Subject: Transmittal of Revision 1 To Service Bulletin Number
V25000-ENG-73-0141

International Aero Engines SERVICE BULLETIN

ENGINE - FUEL AND CONTROL - TO PROVIDE A NEW AISCN14/R ELECTRONIC ENGINE CONTROL
(EEC) SOFTWARE

V2500-ENG-73-0141

Location of the Electronic Engine Control (EEC)
Figure 1

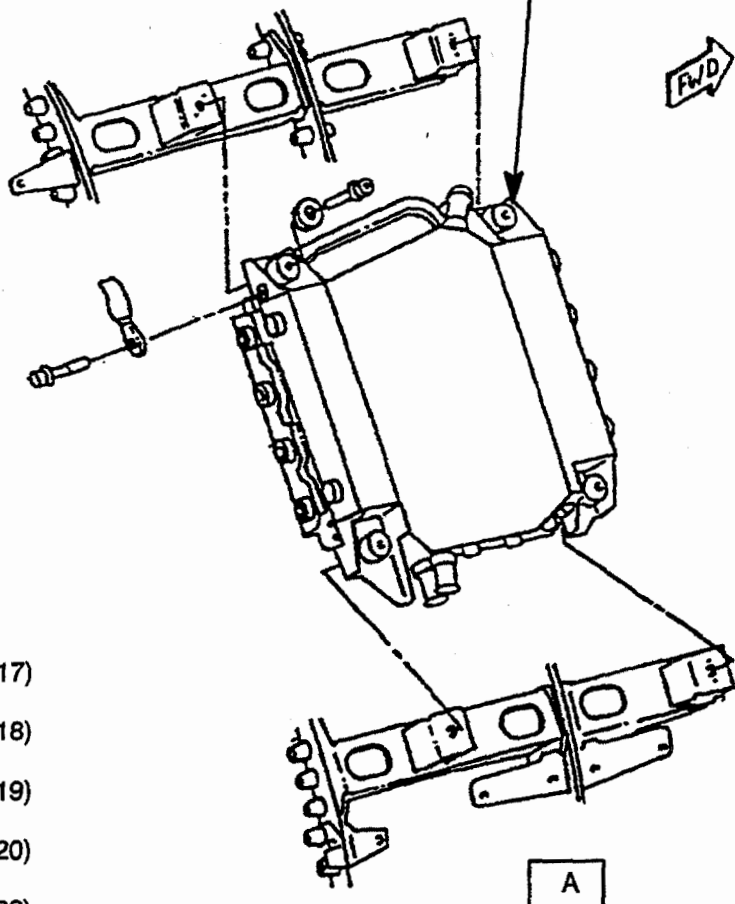
REMOVE THE ELECTRONIC ENGINE CONTROL AND INSTALL THE NEW ELECTRONIC ENGINE CONTROL (EEC) OR OBTAIN THE NEW EEC BY THE INSTRUCTIONS GIVEN IN THE TEXT

***NEW PART NUMBER**

| 808050-04-052 | (2A3417) |
| 798300-15-052 | (2A3418) |
| 798300-16-052 | (2A3419) |
| 798300-17-052 | (2A3420) |
| 798300-18-052 | (2A3422) |

Location of the ACC Front Duct Cover Assembly
Figure 2

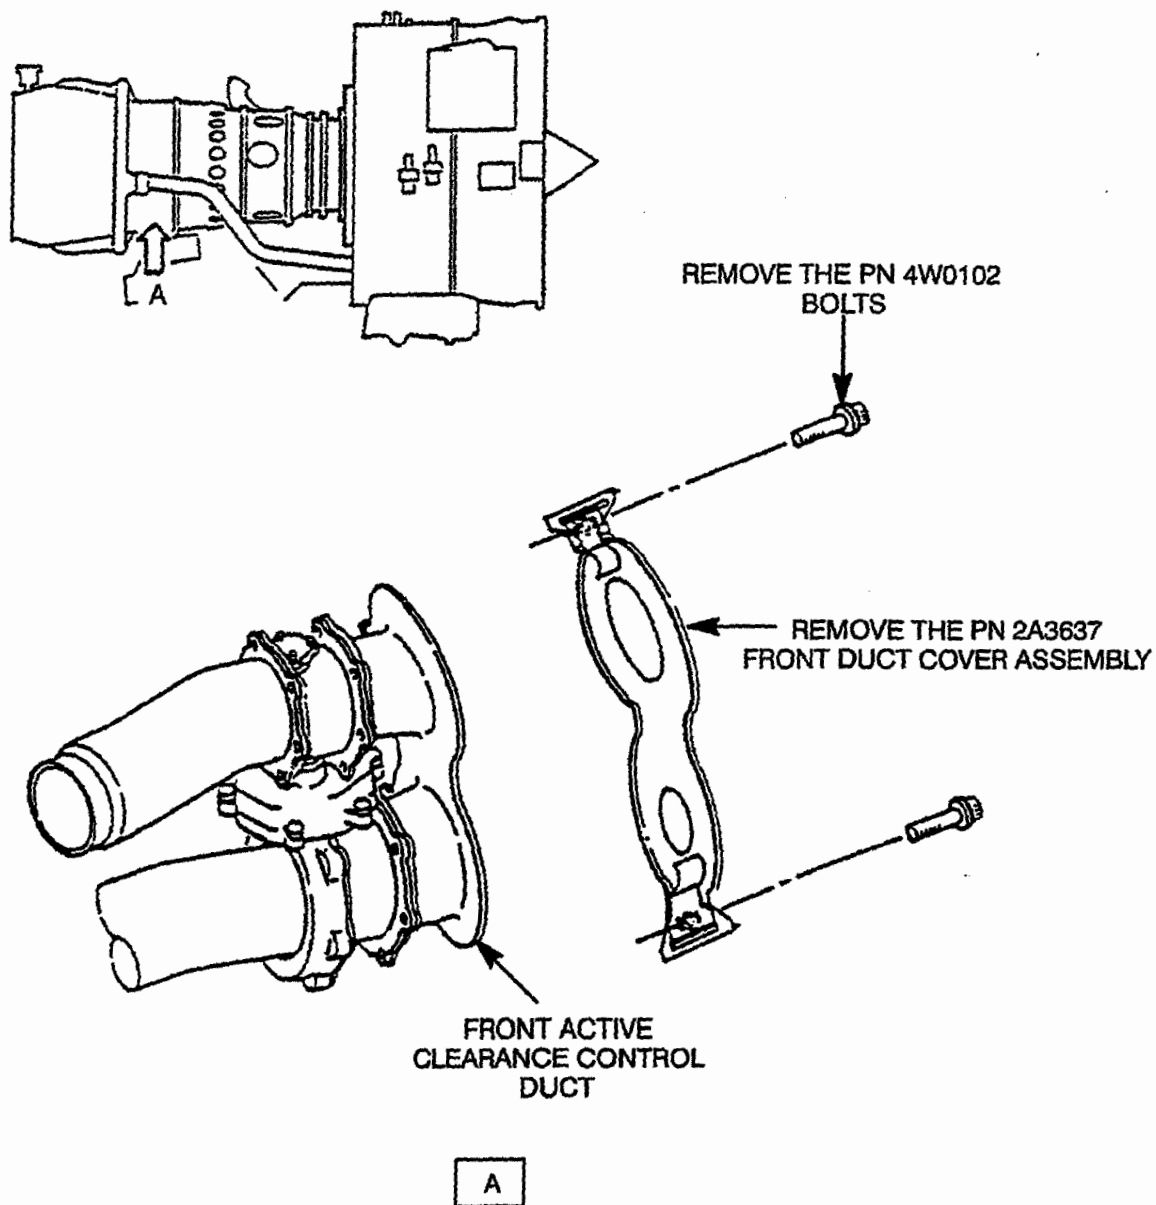
- (1) Remove the old part number (Table 4) Electronic Engine Control by the procedure given in Reference (4), Chapter/Section 73-22-34, Removal/Installation. Refer to Figure 1.
- (2) Remove the Active Clearance Control (ACC) Front Duct Cover Assembly. Refer to V2500-ENG-75-0025 specified in Reference (1), and Figure 2.
 - (a) Locate the Front ACC Duct.
 - (b) Remove the two 4W0102 Bolts from the Front Duct Cover Assembly.
 - (c) Remove the 2A3637 Front Duct Cover Assembly.

NOTE: When you incorporate this Service Bulletin with the new SCN14/R software logic, the Front Duct Cover Assembly given in V2500-ENG-75-0025 must be removed. See Reference (1).

Family Tree - Electronic Engine Control (EEC)
Ref. Catalog Sequence No. 73-22-34. Fig. 01 Item 280
Figure 3 (Sheet 1)

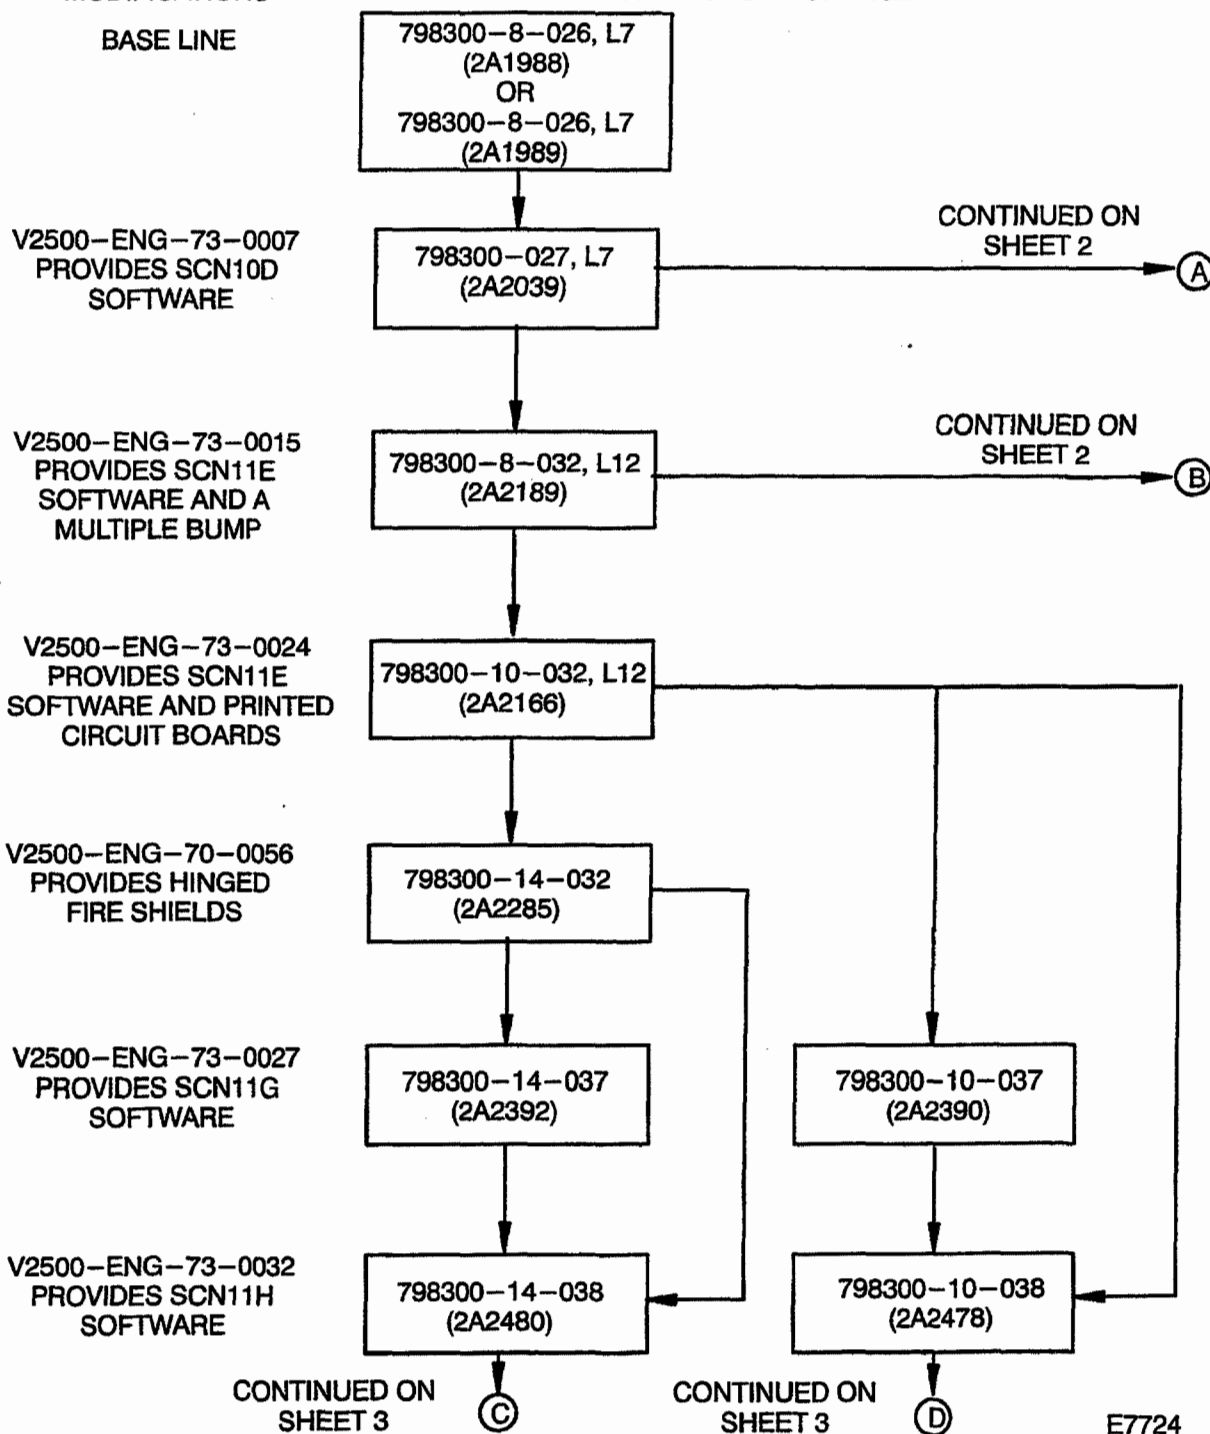
PART NUMBER CHANGE

Family Tree - Electronic Engine Control (EEC)
Ref. Catalog Sequence No. 73-22-34. Fig. 01 Item 280
Figure 3 (Sheet 2)

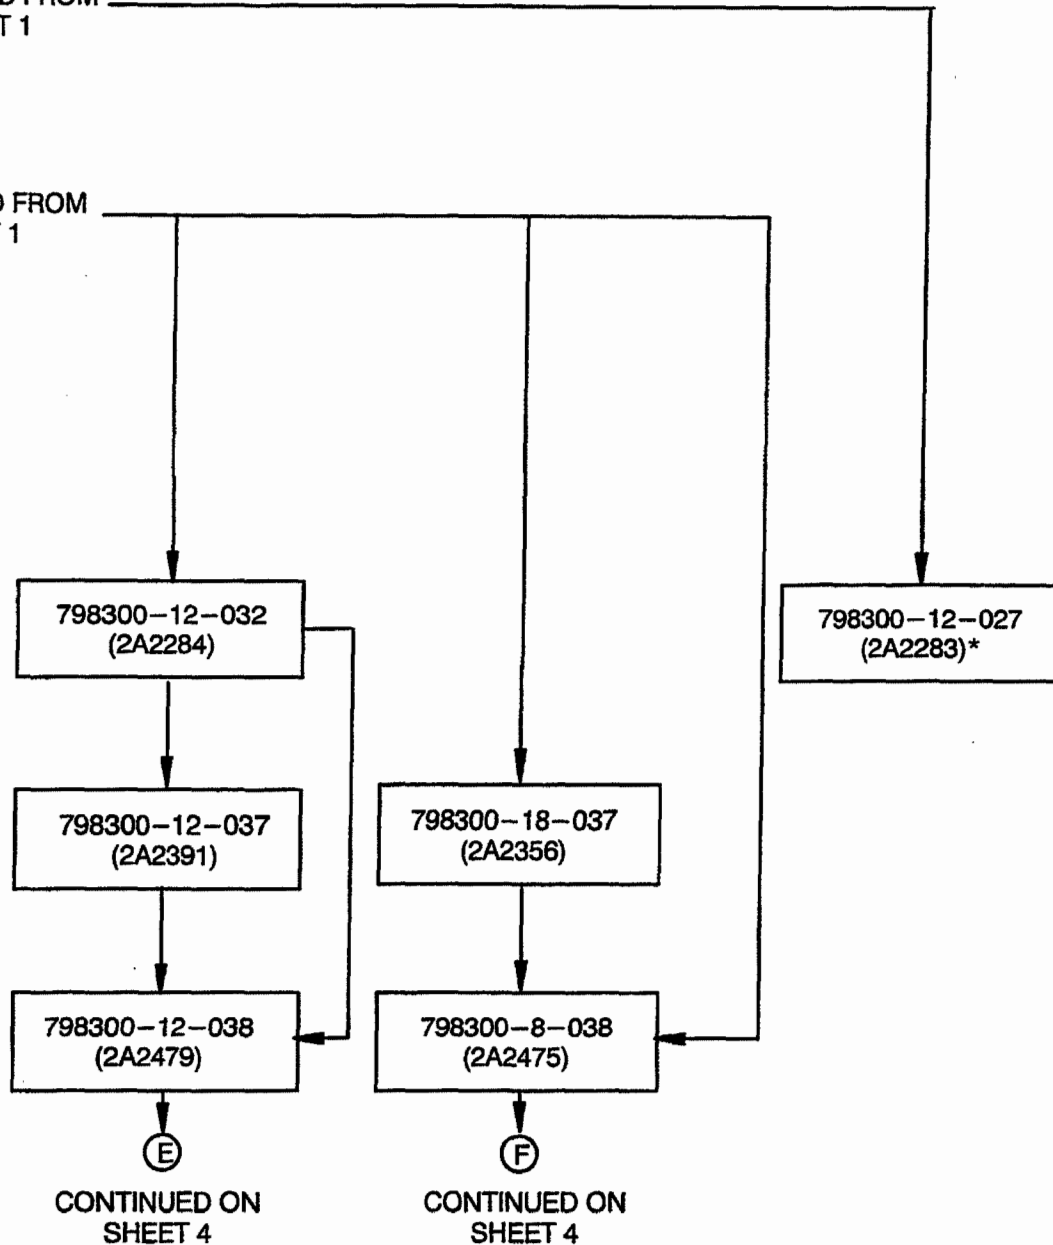
PART NUMBER CHANGE

Family Tree - Electronic Engine Control (EEC)
Ref. Catalog Sequence No. 73-22-34. Fig. 01 Item 280
Figure 3 (Sheet 3)

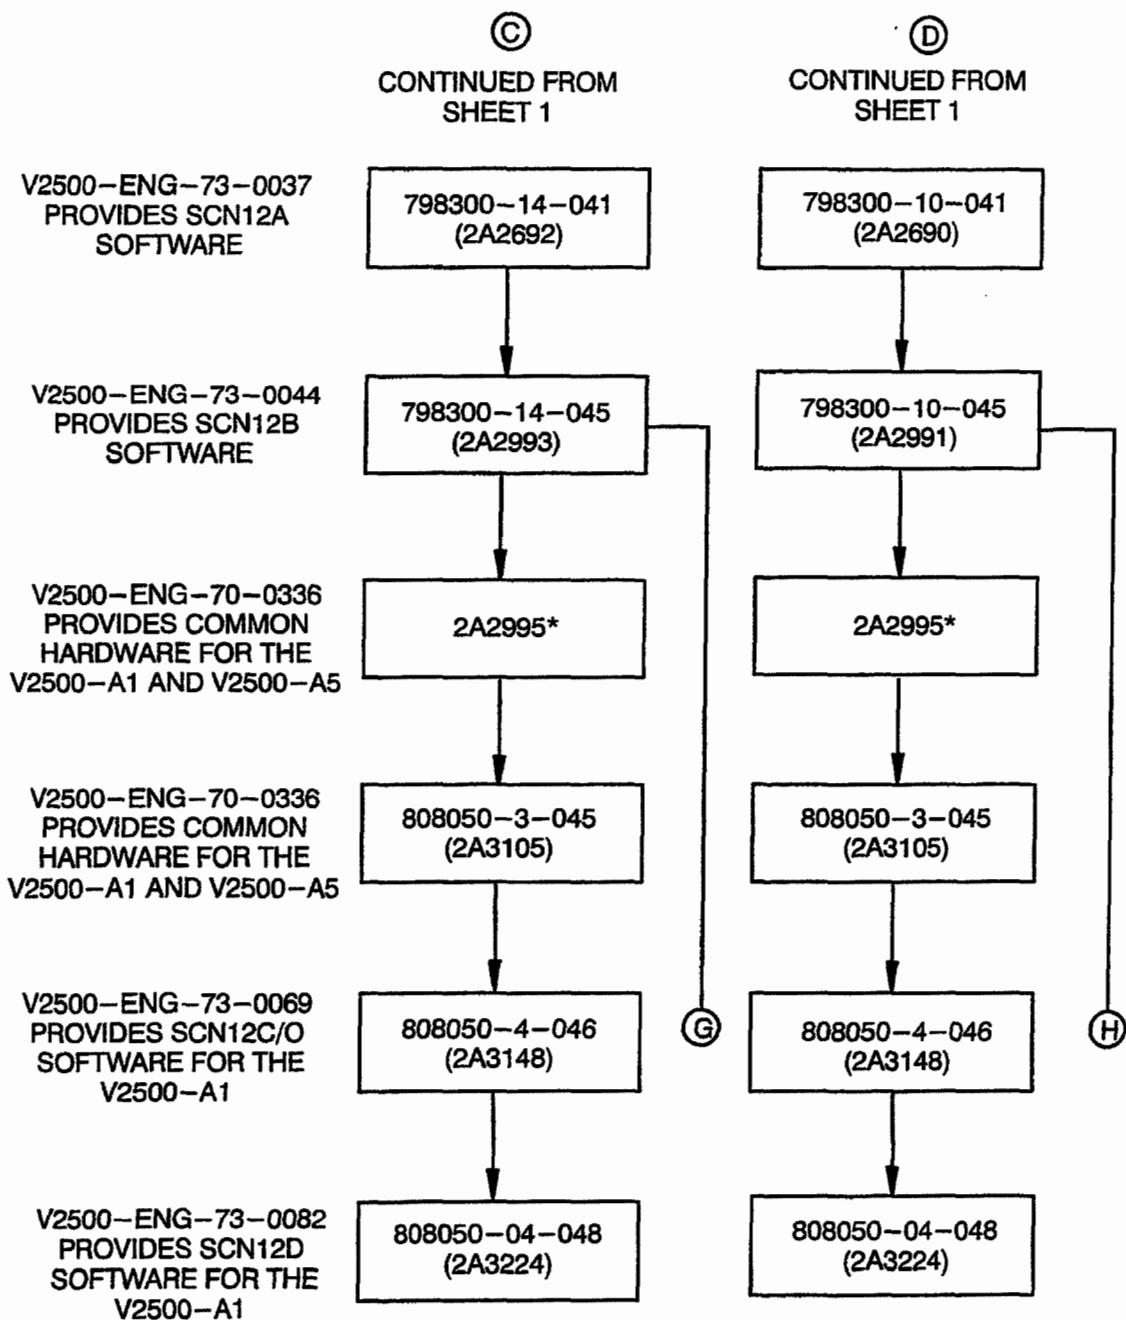
PART NUMBER CHANGE

Family Tree - Electronic Engine Control (EEC)
Ref. Catalog Sequence No. 73-22-34. Fig. 01 Item 280
Figure 3 (Sheet 4)

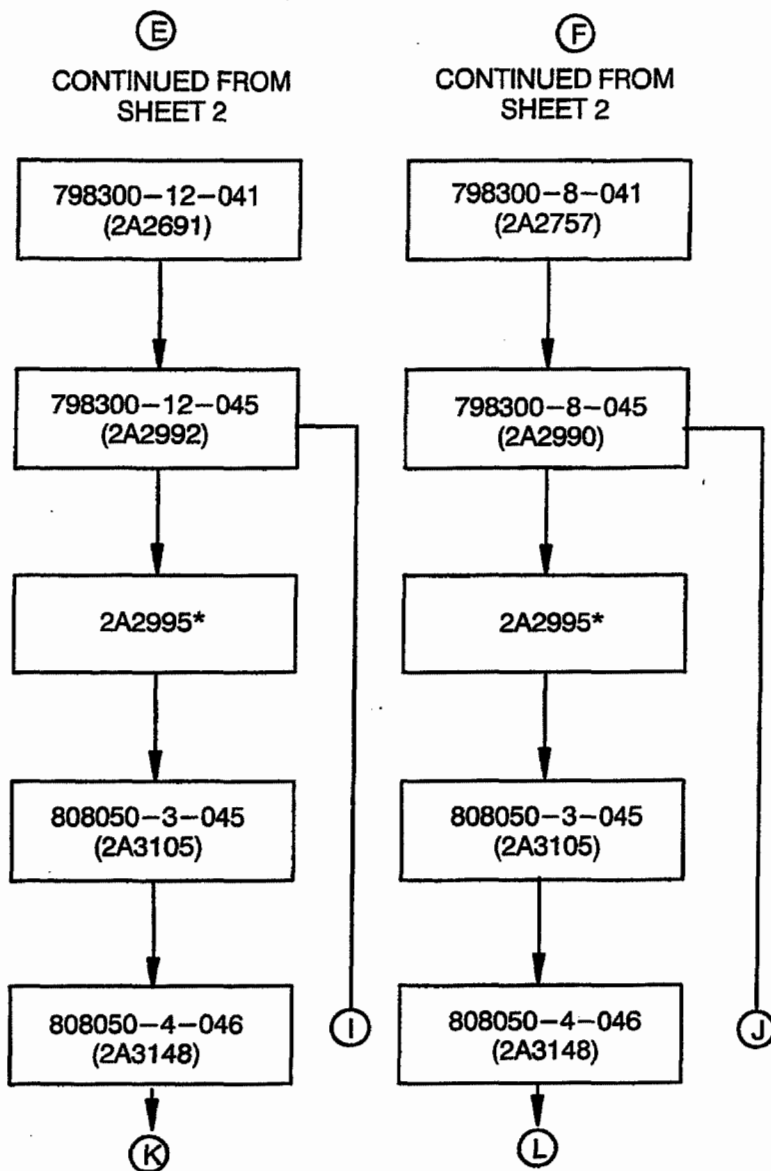
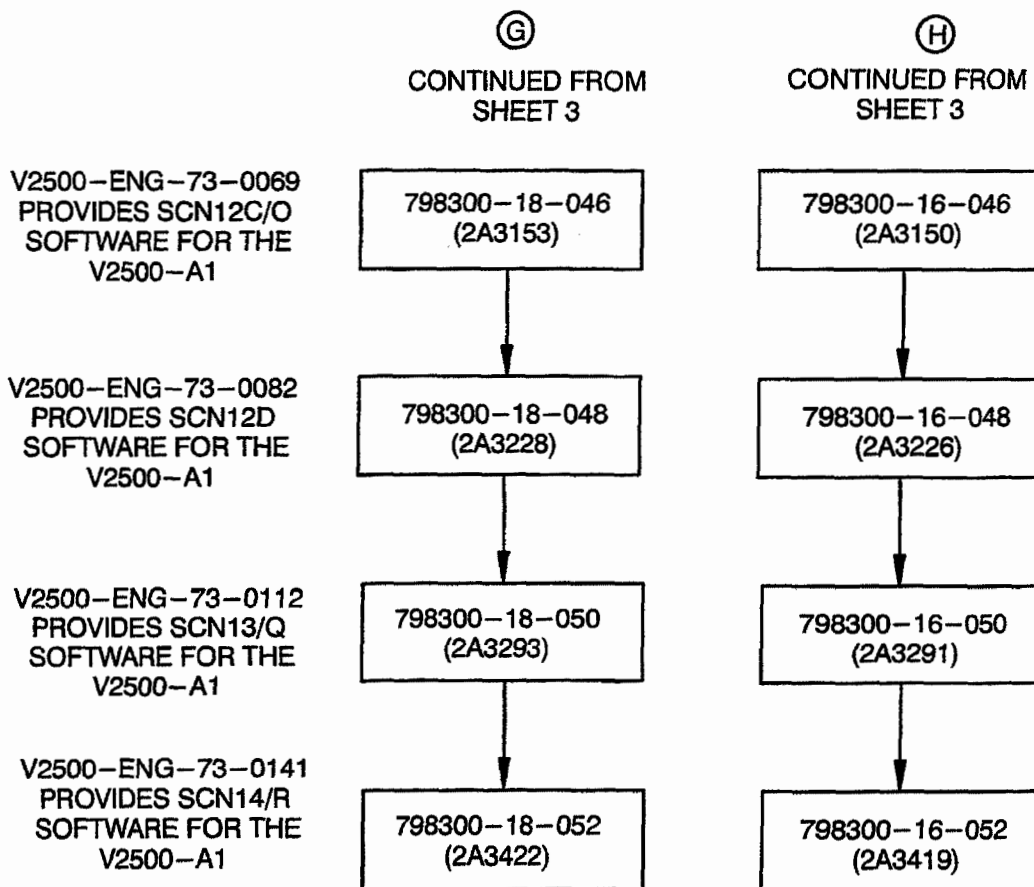
PART NUMBER CHANGE

Family Tree - Electronic Engine Control (EEC)
Ref. Catalog Sequence No. 73-22-34. Fig. 01 Item 280
Figure 3 (Sheet 6)

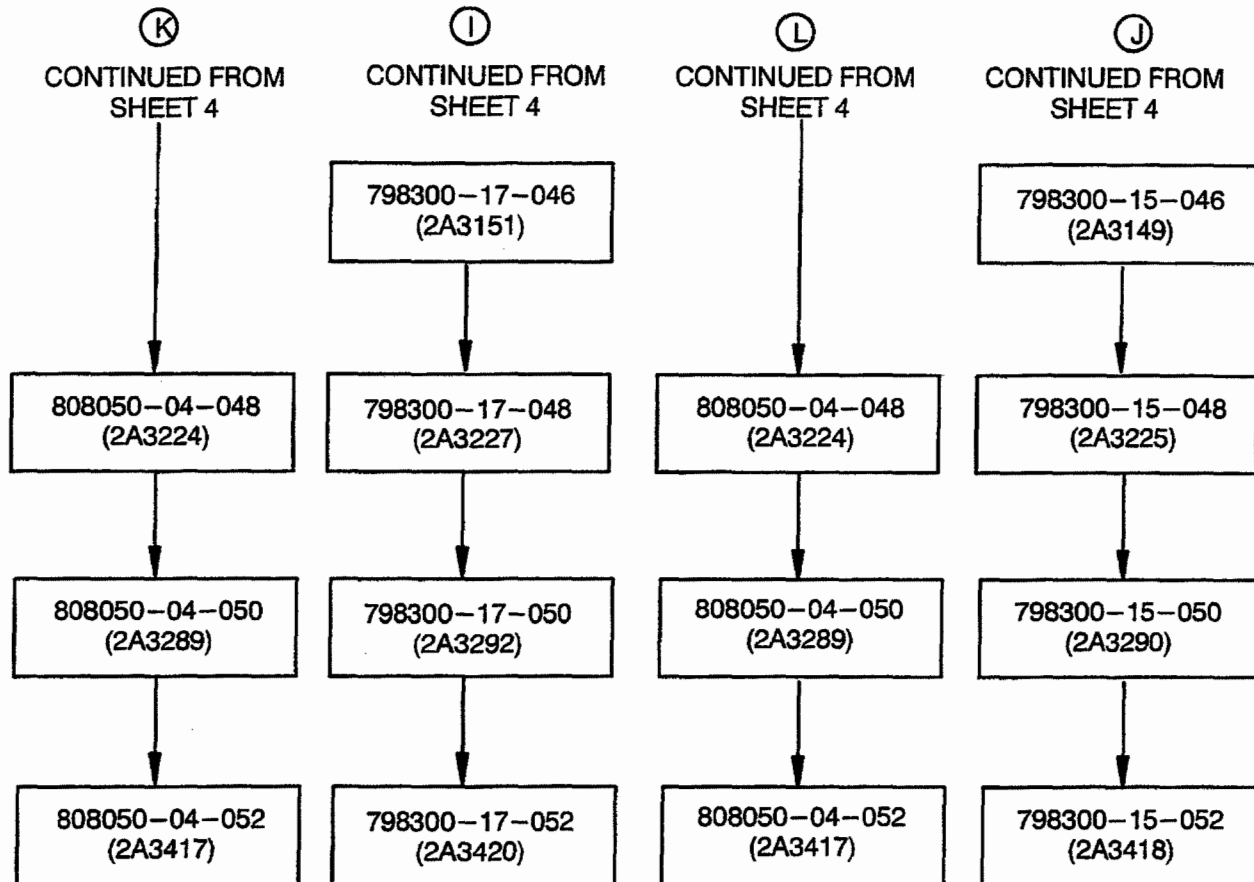
PART NUMBER CHANGE
